UNITARY PLAN UPDATE REQUEST MEMORANDUM

TO Warren MacLennan, Manager Planning North West and Islands
FROM Jo Hart, Principal Planner, Planning North West and Islands
DATE 18 October 2019
SUBJECT **Designation in accordance with s168 of the Resource Management Act of the Auckland Unitary Plan(AUP) Operative in part (15 November 2016)**

CONSENT ORDER

Annexure D – Proposed Temporary Traffic Management Plan (Ref. L1N171201)

PakNSave Access TMP - Lincoln Road Section 1

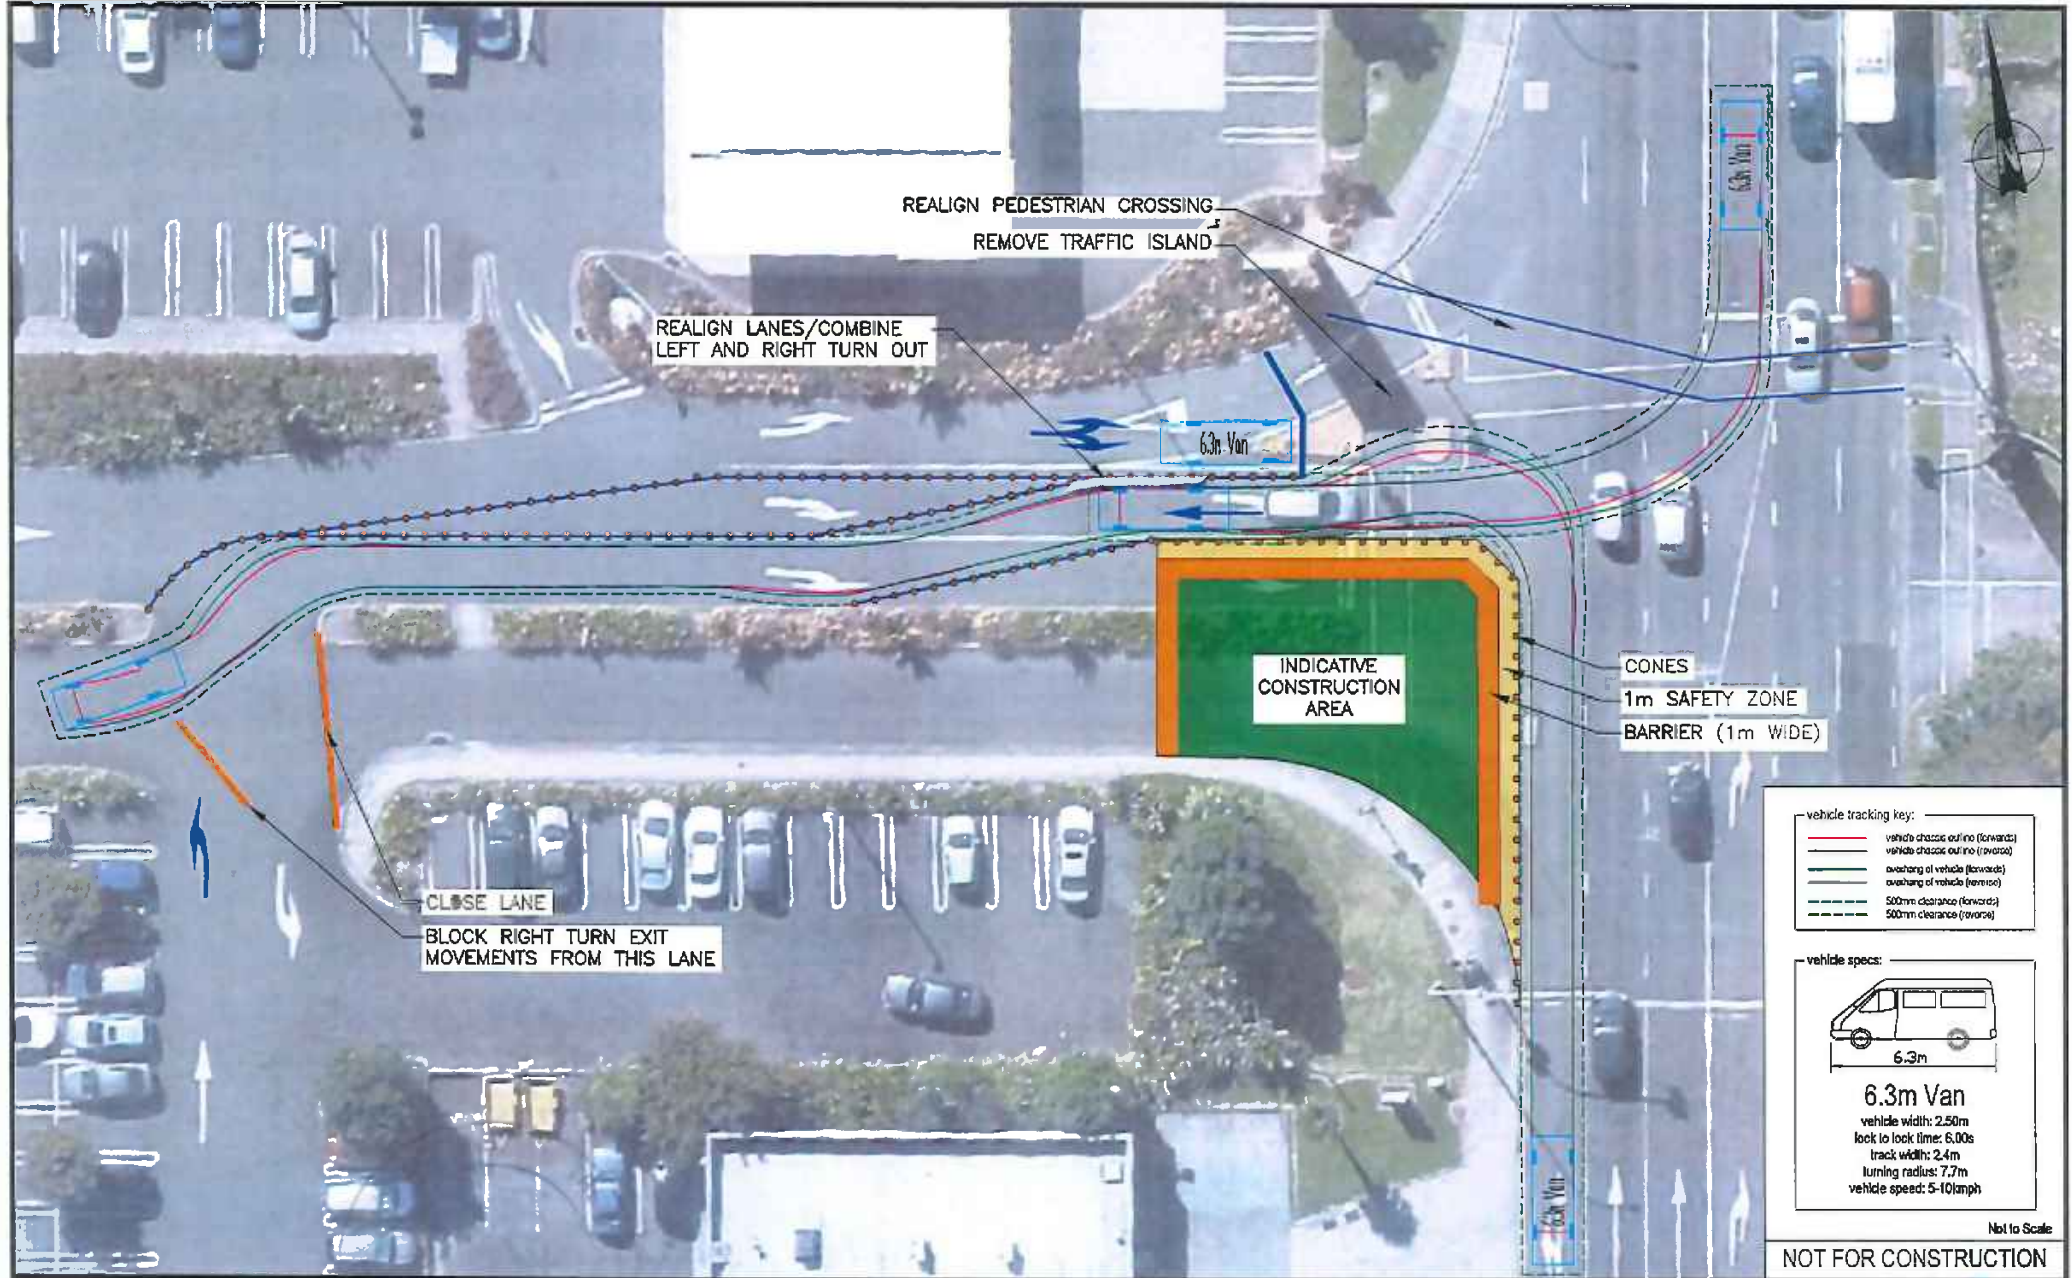
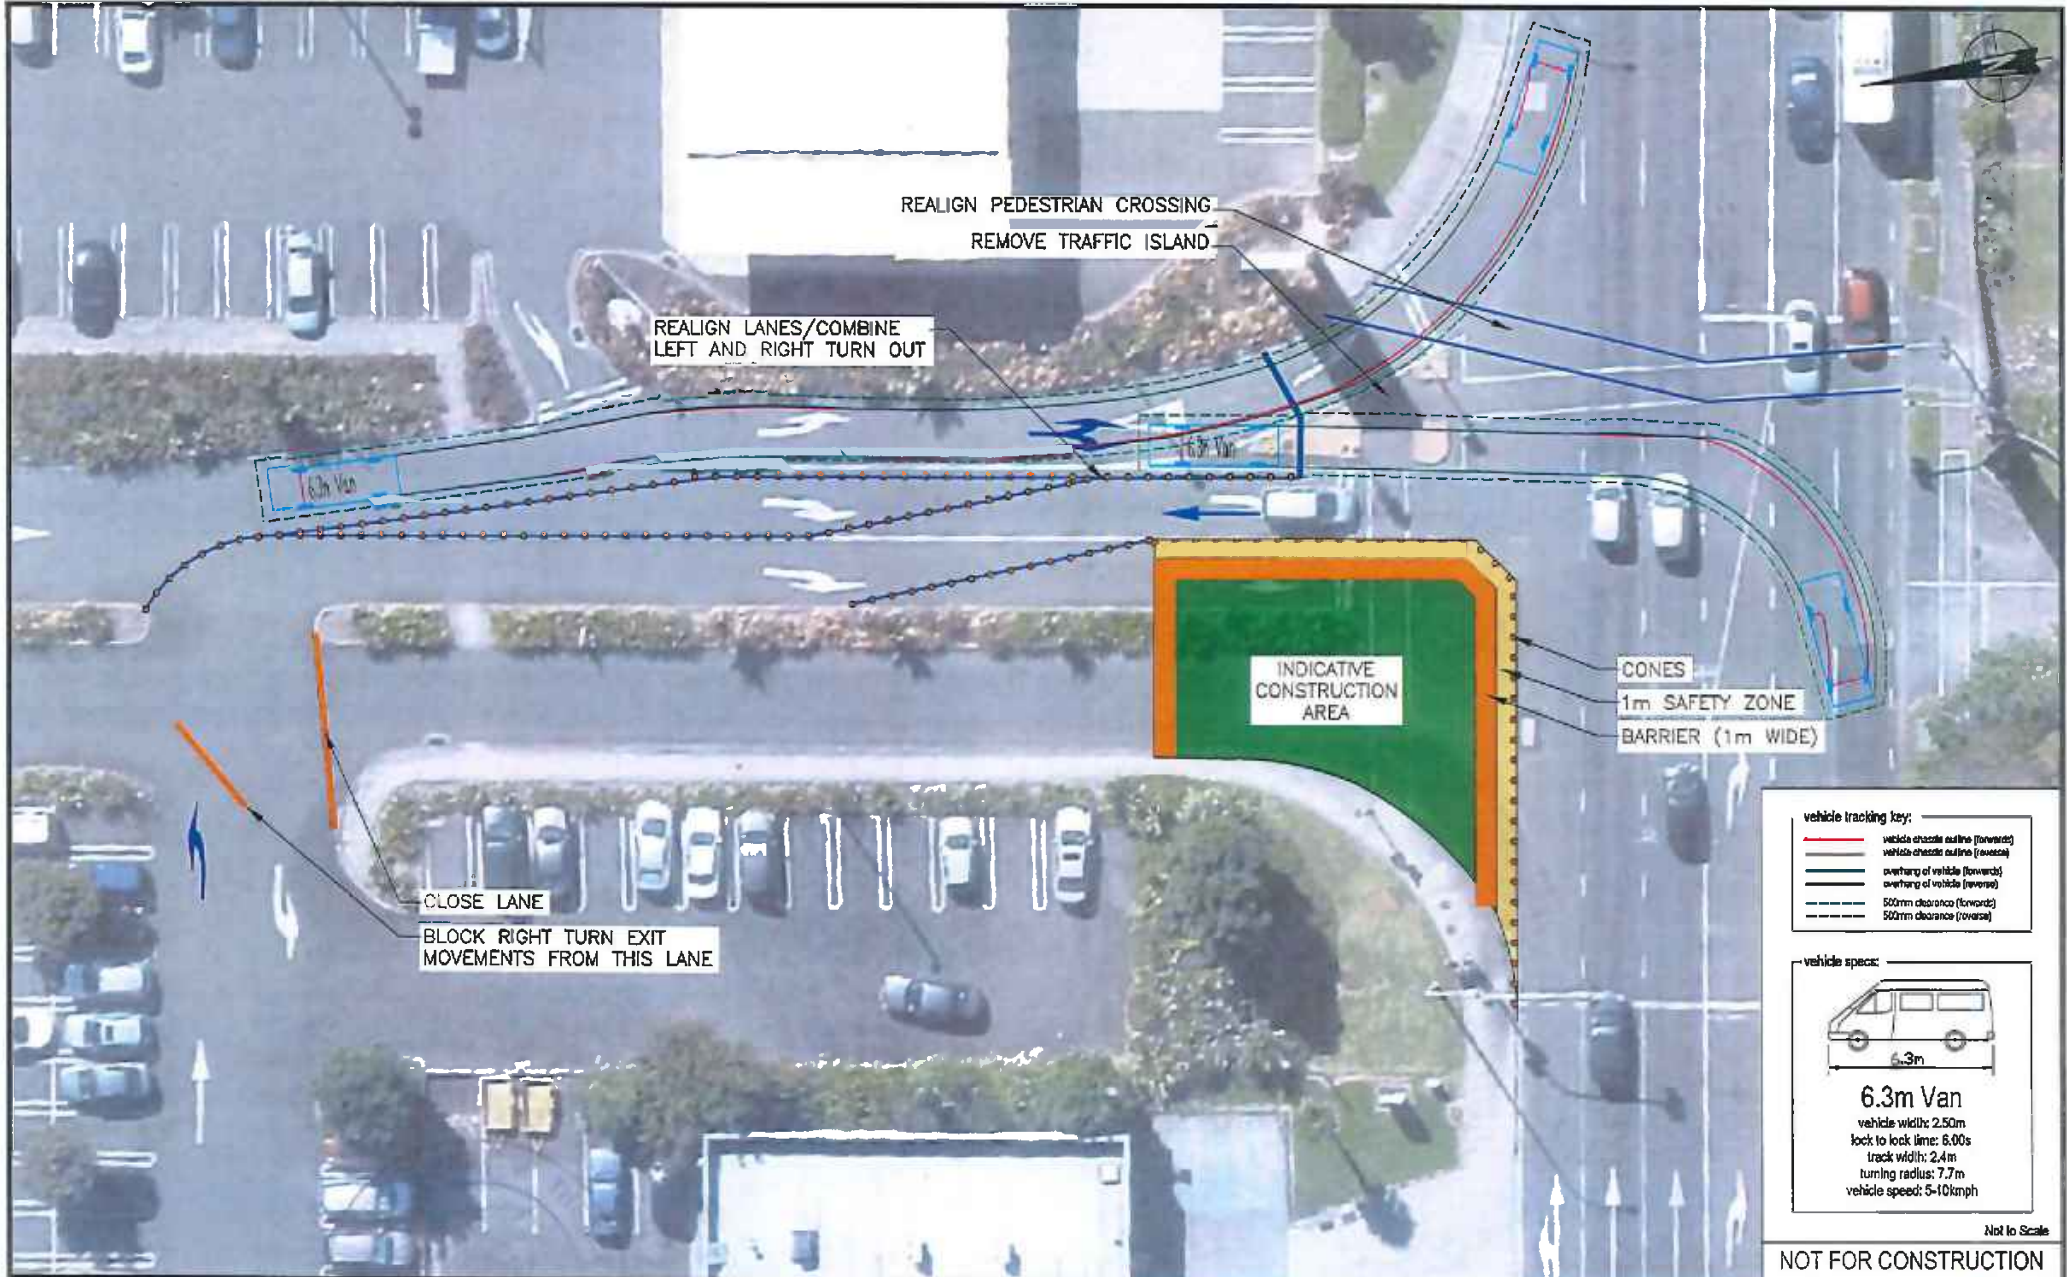
- The ped crossing across Pak n Save access (Boulevard) has been blocked. This is again not good for ped safety. It may encourage pedestrian to cross unsafely. Pedestrian access must be maintained at all times. Have any alternative arrangements been made to provide a safe pedestrian environment?
The layout is indicative only. A pedestrian crossing across the Pak'n Save access will be provided, however the details of this cannot be confirmed until the extent and location of the trenching required is confirmed.

- Signal visibility may be an issue due to the changes in the layout.
Visibility to signals on the Lincoln Road approaches to the intersection will not be affected by the proposed construction works. All construction works will be located within the Pak'n Save access. Two to four temporary signal poles will replace two signal posts currently located in the splitter island on the Pak'n Save exit – these can generally be located within the work area and will provide for pedestrian crossing signals (and call button) across the Pak'n Save approach, the tertiary displays for the Lincoln Road northbound approach, the secondary displays for the Laidlow College approach, and dual primary displays for the Pak'n Save approach. The attached plans show two temporary signal poles in the work area; however, if each temporary pole can only accommodate one set of signals, then four temporary signal poles will be needed. In addition, for this scenario, a temporary primary signal will be installed on the Pak'n Save exit approach, to the left of the lane. Visibility to the existing tertiary signal will be unaffected. Visibility to the secondary signal from the Pak'n Save access approach may be affected depending on the final location of the trench and what equipment/machinery is used, however the dual primary displays on a temporary pole in

- To accommodate the northern ped crossing with proper protection, a new software will be required.
Agreed.
- The pedestrian on the northern side has been realigned but there is no mentioning of any related hardware to activate the pedestrian and to operate it safely (also refer to comment 1 above about the direct conflict).
The layout is indicative only, intended to demonstrate that there is sufficient space to accommodate the proposed CTMP layout. All required hardware will need to be provided.

- The ped crossing across Pak n Save access (Boulevard) has been blocked. This is again not good for ped safety. It may encourage pedestrian to cross unsafely. Pedestrian access must be maintained at all times. Have any alternative arrangements been made to provide a safe pedestrian environment?

- To accommodate the northern ped crossing with proper protection, a new software will be required.
- The pedestrian on the northern side has been realigned but there is no mentioning of any related hardware to activate the pedestrian and to operate it safely (also refer to comment 1 above about the direct conflict).

the work zone will be able to act as the third set of signals for this approach. Existing and proposed temporary signal pole locations are now shown on the plans.

PaknSave Access TMP - Lincoln Road Section 3

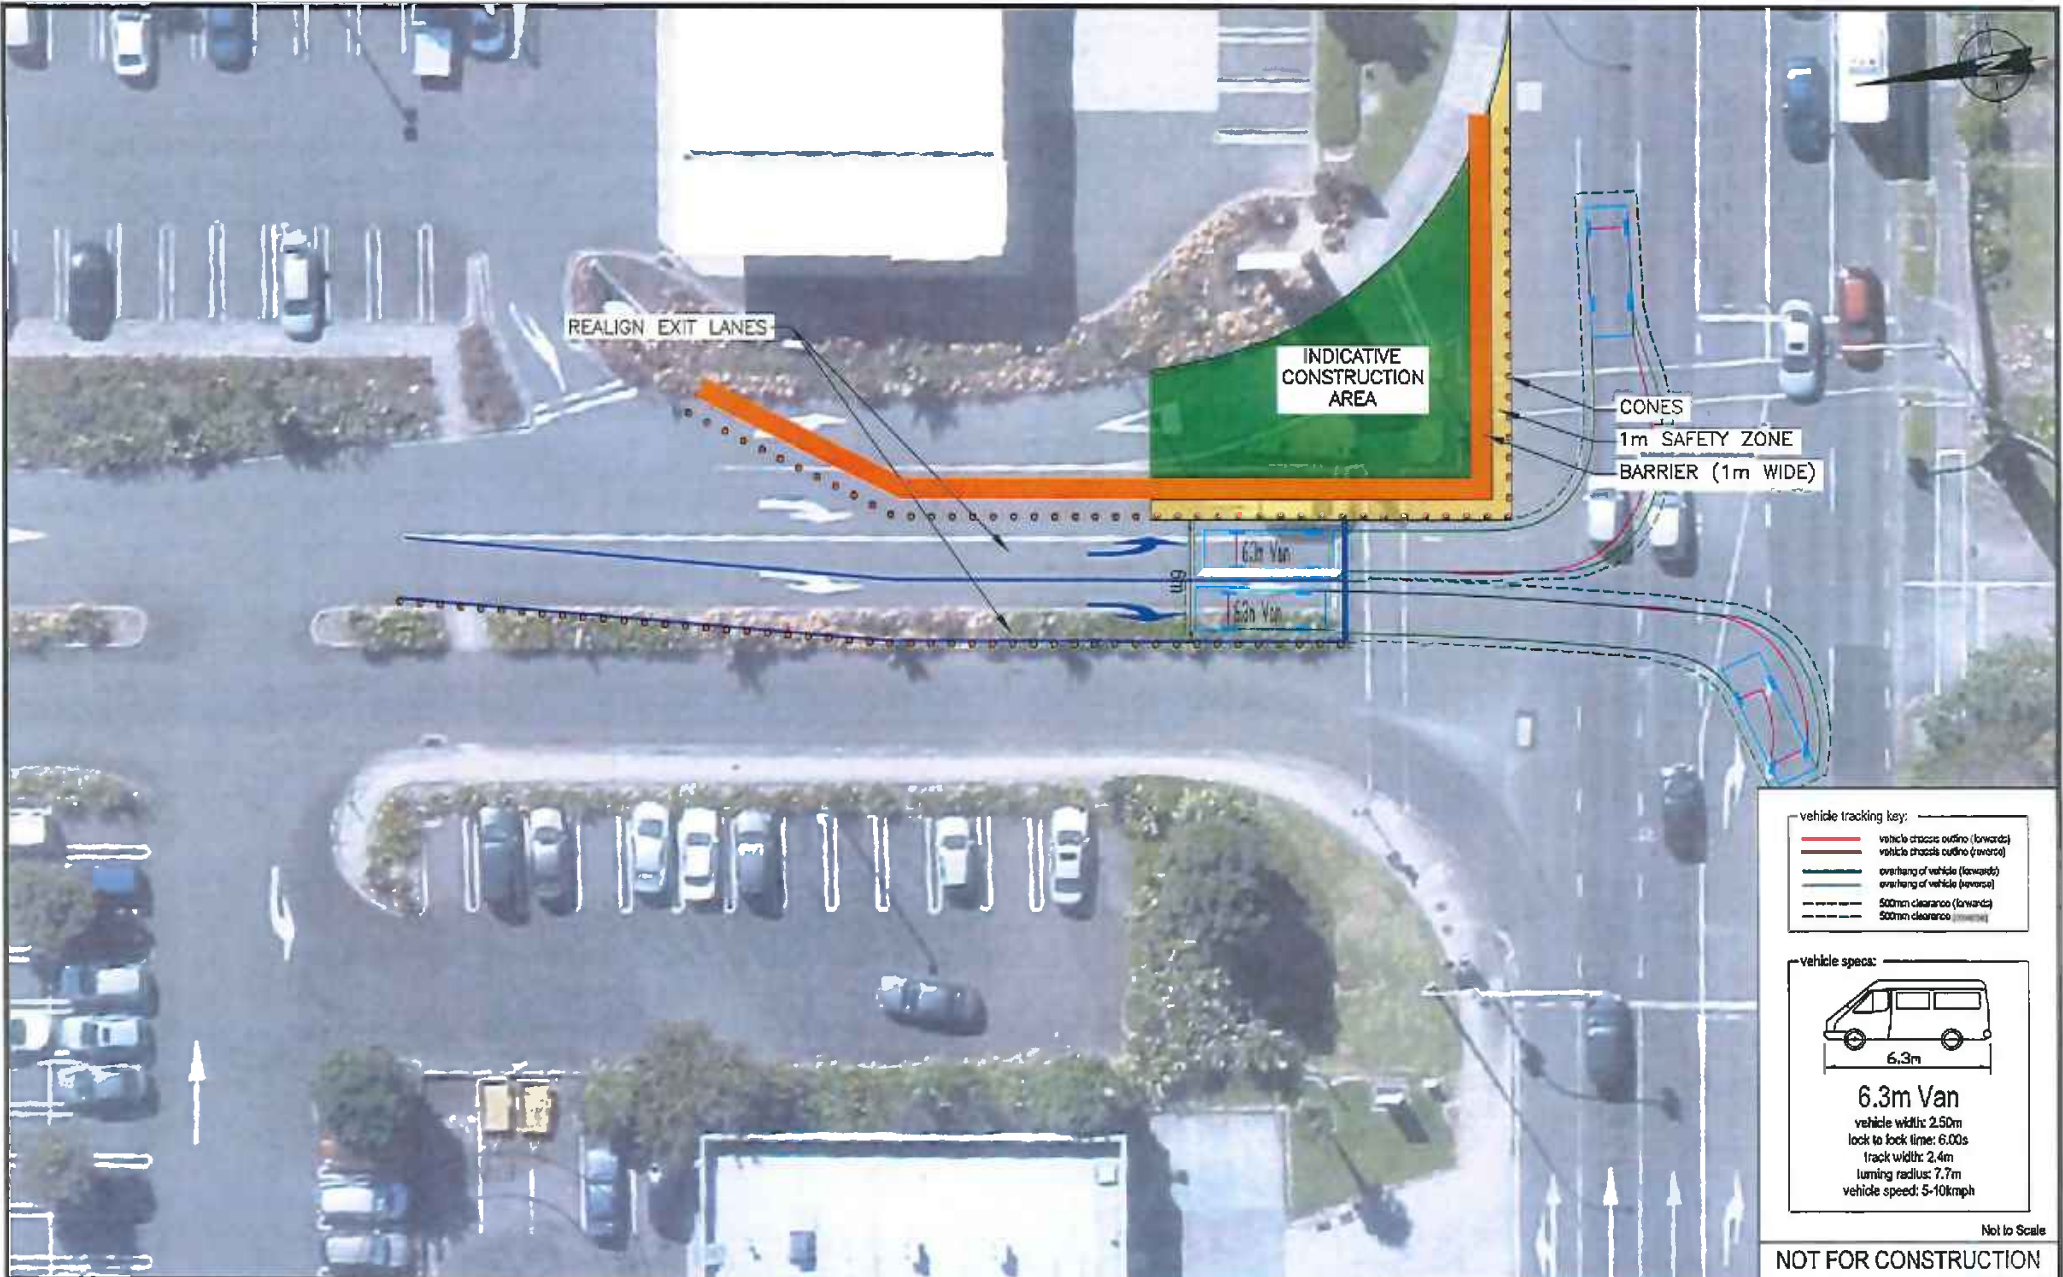
- The left turn exiting the side road (Pak n Save access) is in conflict with the pedestrian crossing. Current software does not provide protection due to a non-conflict due to the existence of slip lane. Removal of the slip lane creates this direct conflict and a new software will be required to address this issue. Without providing a proper protection this arrangement is not recommended as it could result in serious crashes.
The left turn will be managed with signals, and will not run at the same time the pedestrian crossing has a green signal.

- No pedestrian access provided at the NW corner of the intersection. No alternative arrangements shown either.
- The left turn exiting the side road (Pak n Save access) is in conflict with the pedestrian crossing. Current software does not provide protection due to a non-conflict due to the existence of slip lane. Removal of the slip lane creates this direct conflict and a new software will be required to address this issue. Without providing a proper protection this arrangement is not recommended as it could result in serious crashes.
- The changes lay out on the side road approach may affect the detector activation.
- What signal equipment has been provided on the Boulevard to match the proposed layout?
